DESIGN REVIEW BOARD DECISION ON DESIGN RESPONSE CONFERENCE APPLICATION

Date: January 24, 2013
File No.: DRV12-00921
Project Name: Lake Street Place
Applicant: Rick Chesmore with Chesmore|Buck Architecture

ENLARGED COURTYARD PLAN

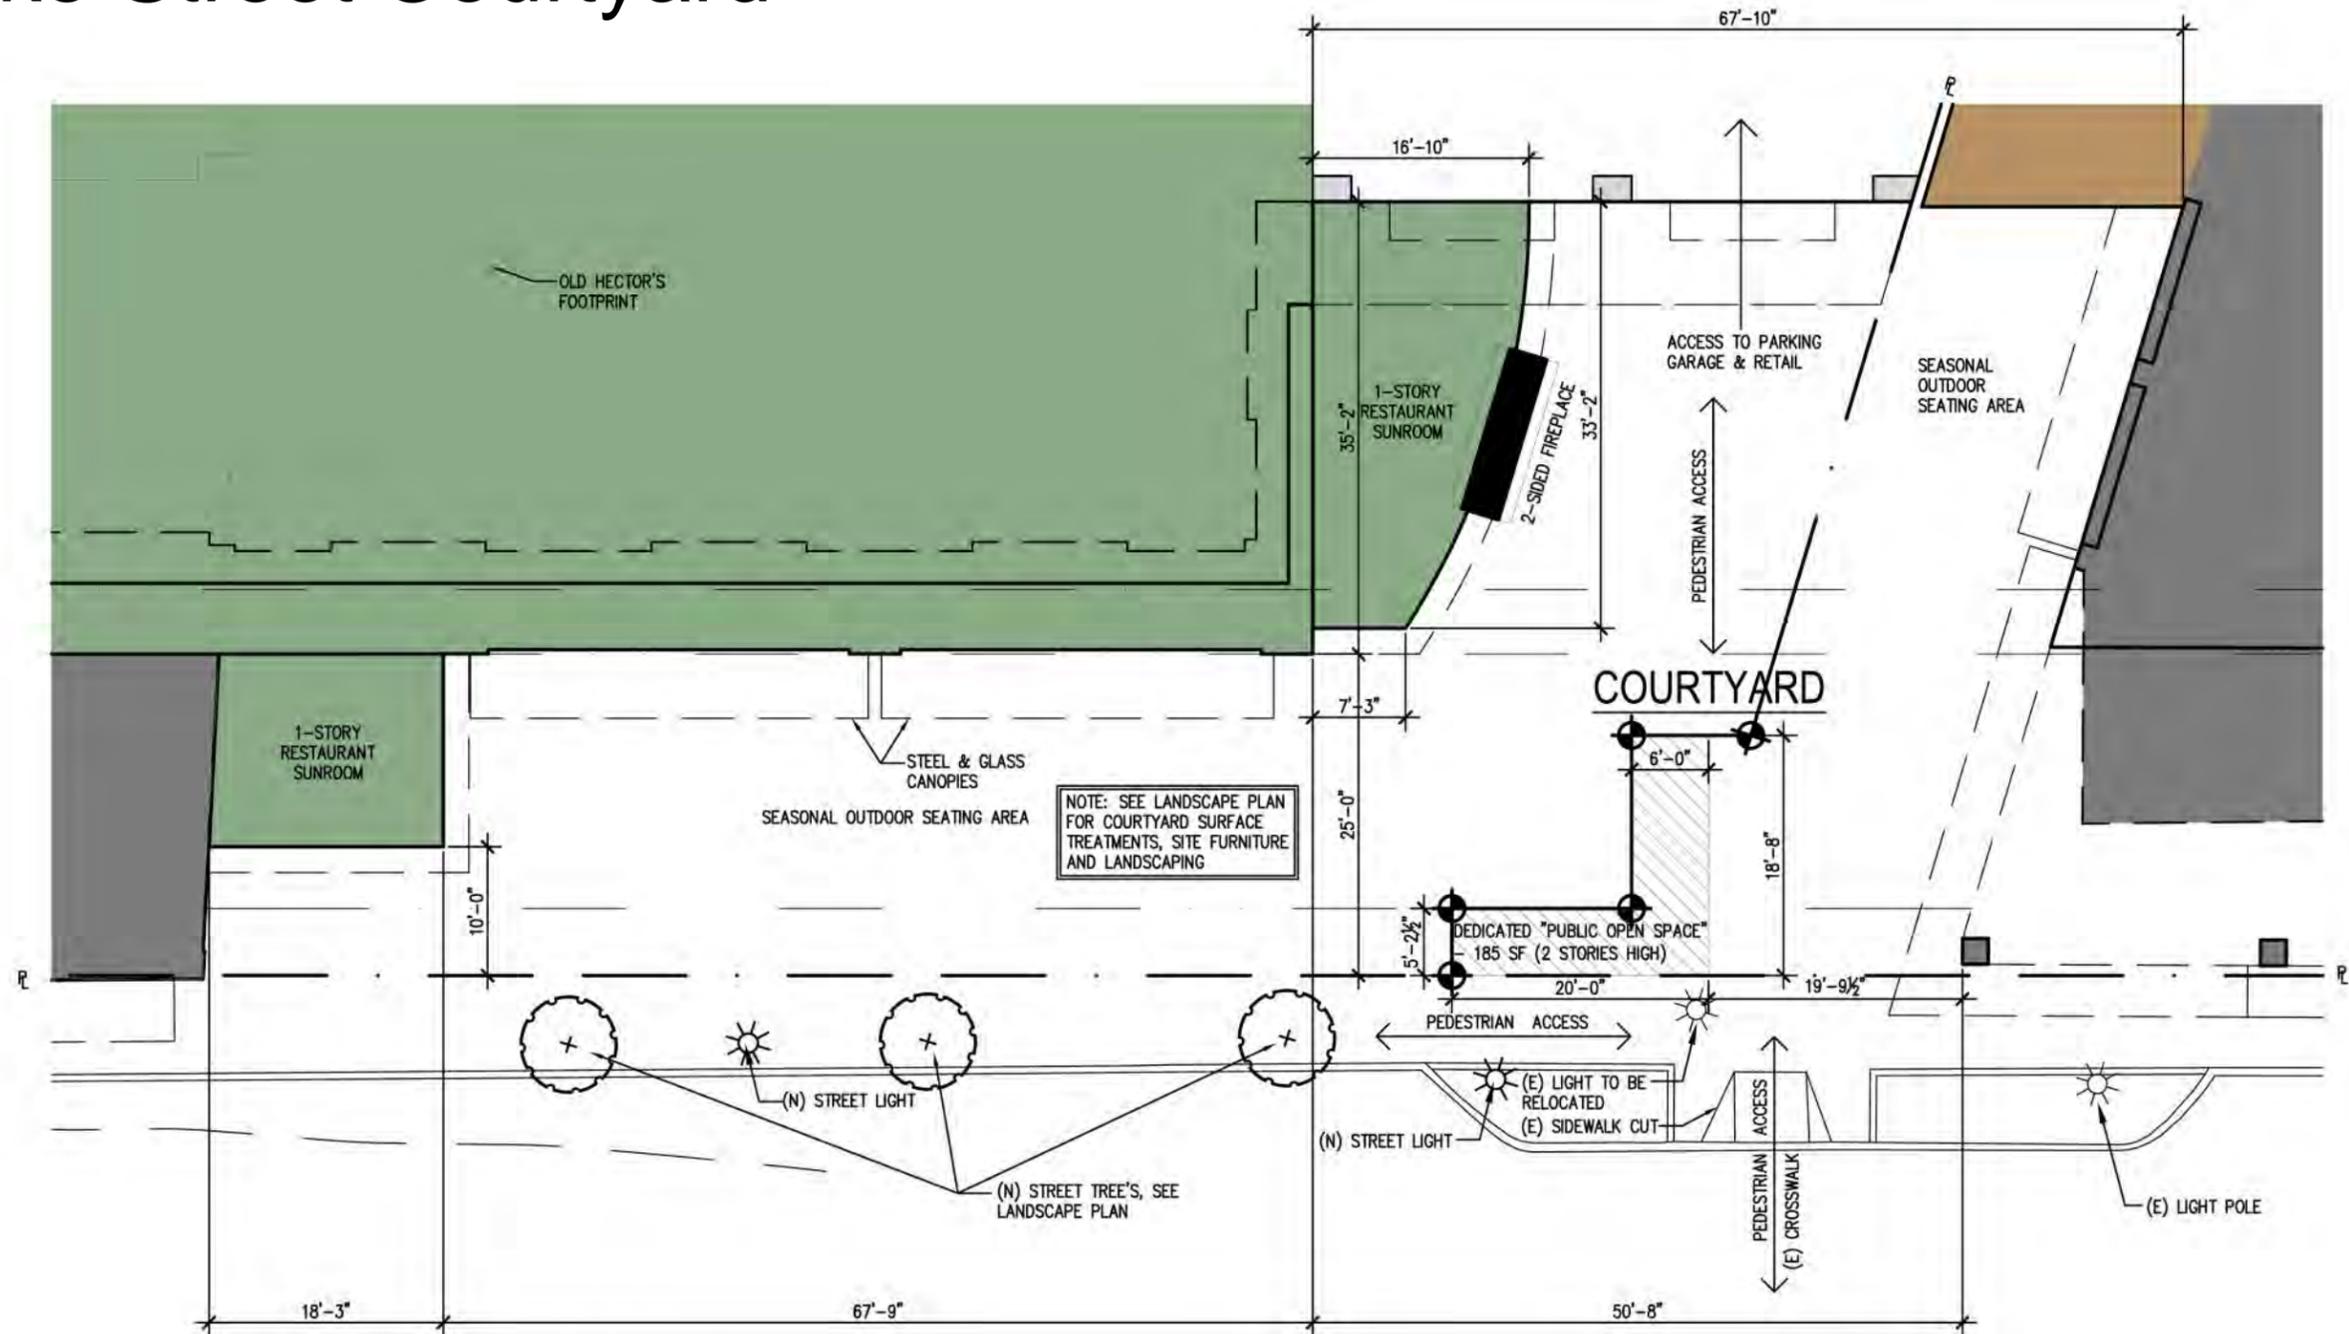
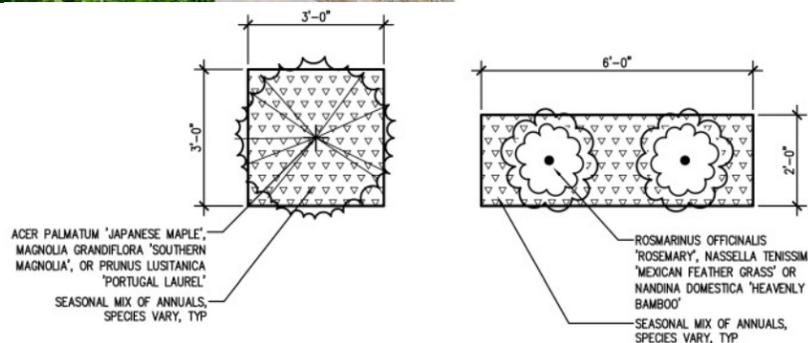
7. Detailed courtyard plans that specify that the outdoor seating areas are modular and delineated by moveable planters, seating, and railings.
- C. All furnishings (such as planters, seating, and railings) in the courtyard off Lake Street South shall remain modular and shall not be permanently affixed.

The DRB also discussed pedestrian access as it related to the courtyard and lighting. The DRB expressed concern with the original courtyard design and felt that it was too cluttered by outdoor seating, a large canopy, and the placement of two fireplaces and associated chimneys. The DRB also discussed the need for the courtyard outdoor seating areas boundaries to be non-permanent and that the paving pattern design should be revised to flow **with 'L' shape of the** courtyard layout.

The DRB also concluded that courtyard design meets the design guidelines on the condition that detailed courtyard plans are submitted with the building permit specifying that the outdoor seating areas be delineated by moveable planters, benches, and railings. By maintaining courtyard furnishings that are modular rather than permanently affixed, the space can be adapted for both private and community functions as described by the applicant in their proposal.

1 LANDSCAPE PLAN - COURTYARD & FRONTAGE IMPROVEMENTS

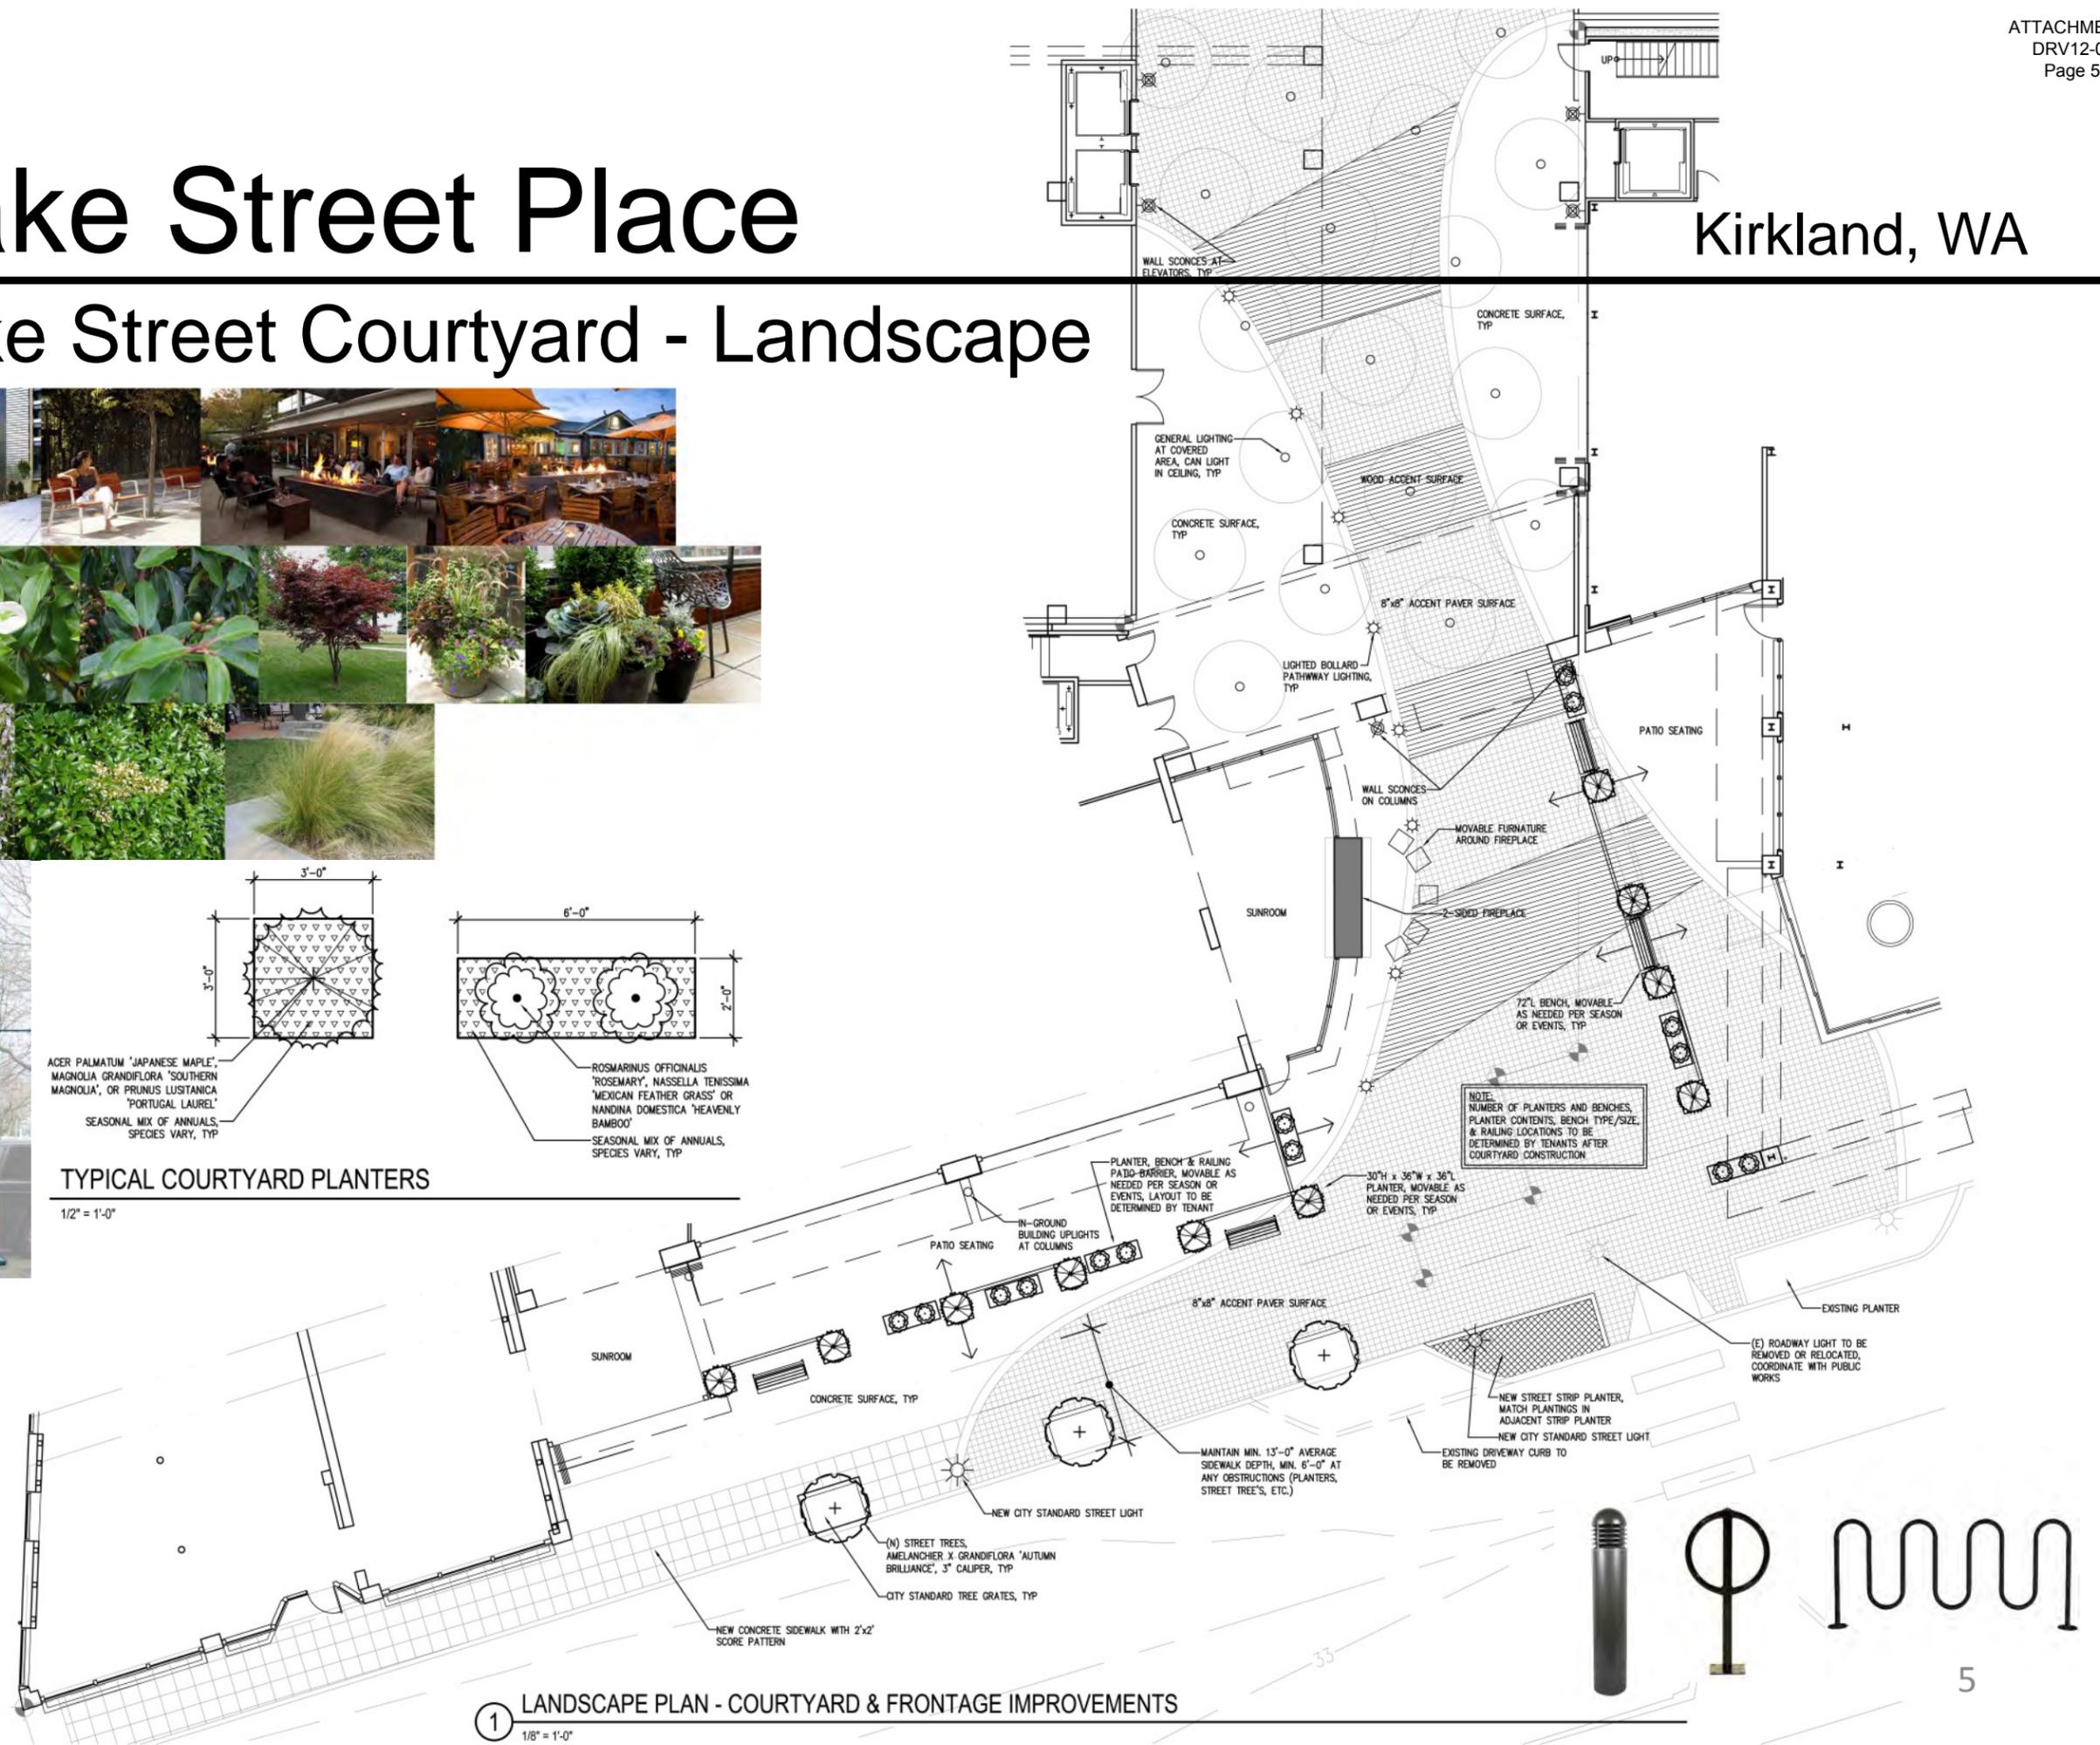
- South façade of the Main Street Building that is consistent with Option 1 (infill horizontal panel siding).
 3. Detailed landscape plans that:
 - Replace the *Salix discolor* (American pussy willow) near the public walkway with a different plant species that is columnar and evergreen.

- Update the plant species to have additional diversity and seasonal interest. The resulting planting plan shall be dynamic with a variety of color and contemporary plant species which expand upon the *Phyllostachys nigra* (black bamboo) aesthetic proposed near the public walkway.

2. Conclusion: The DRB concluded that the proposed landscape plan meets the design guidelines with the following conditions:
 - Replace the Salix discolor (American pussy willow) near the public walkway with a different plant species that is columnar and evergreen.
 - Update the plant species to have additional diversity and seasonal interest. The resulting planting plan shall be dynamic with a variety of color and contemporary plant species which expand upon the Phyllostachys nigra (black bamboo) aesthetic proposed near the public walkway.

Northeast Elevation – Options at alley corner

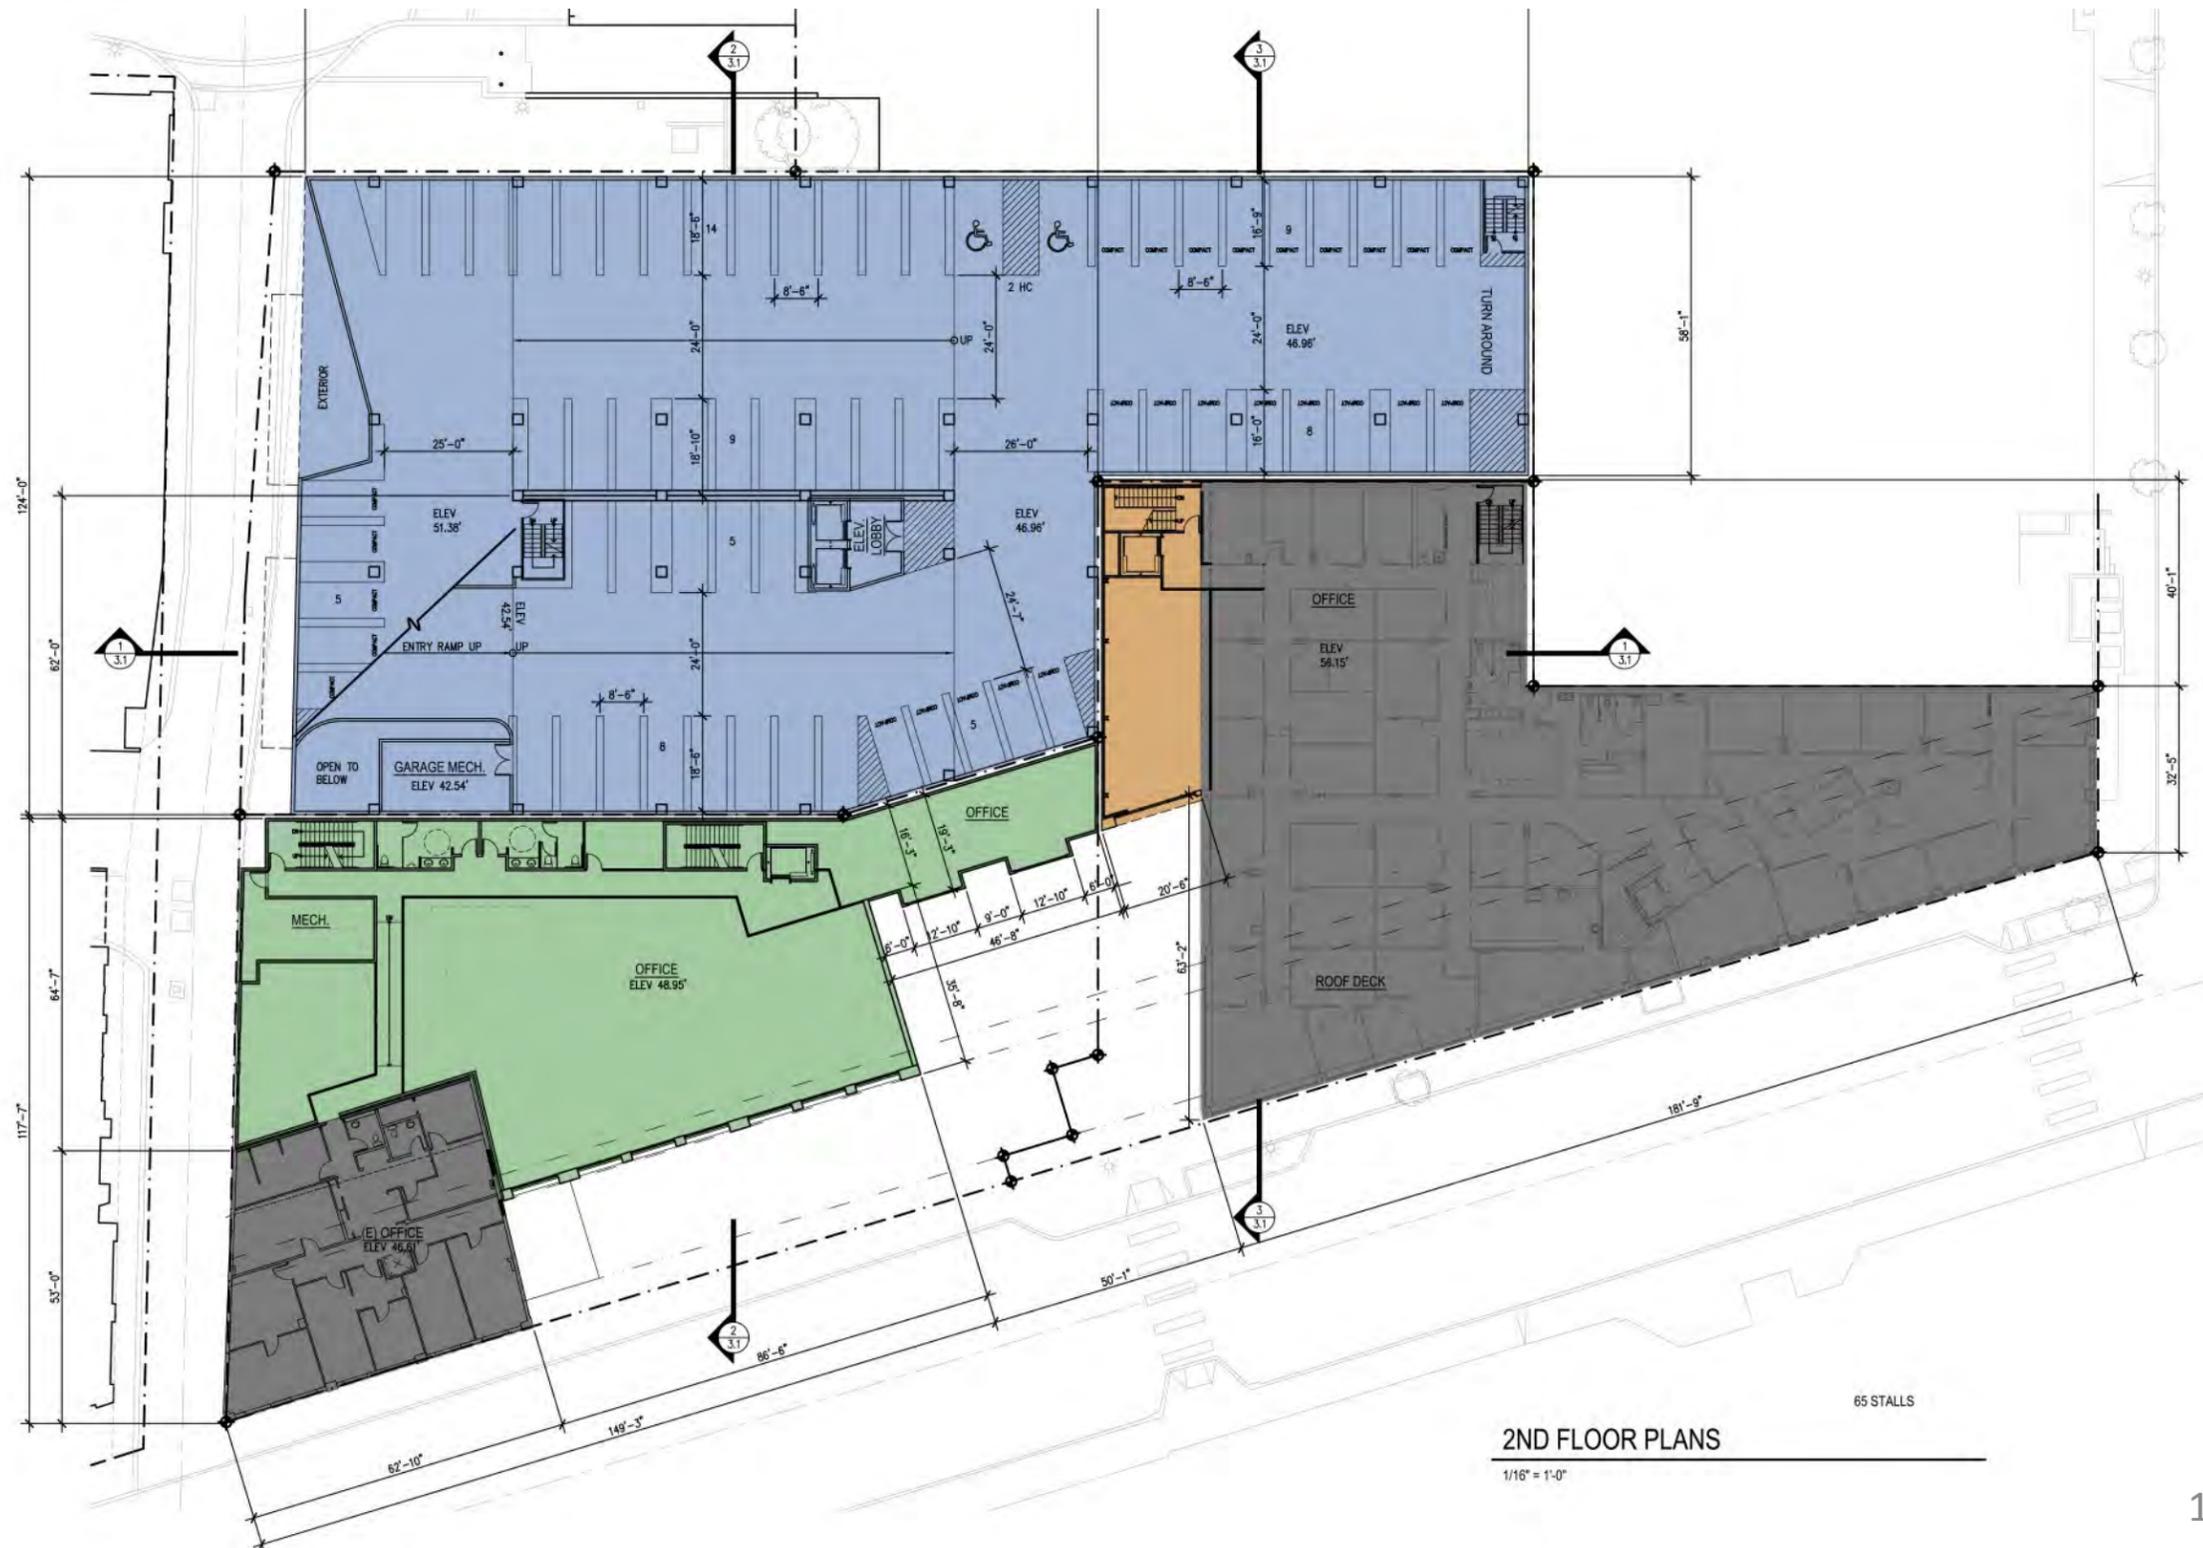
- North façade of the Main Street Building that is consistent with Option 2 (separated roof forms for each bay).
 - Northeast façade of the Main Street Building that is consistent with Option A3 (CMU base and horizontal panel siding above).

- North façade of the Main Street Building that is consistent with Option 2 (separated roof forms for each bay).
- Northeast façade of the Main Street Building that is consistent with Option A3 (CMU base and horizontal panel siding above).
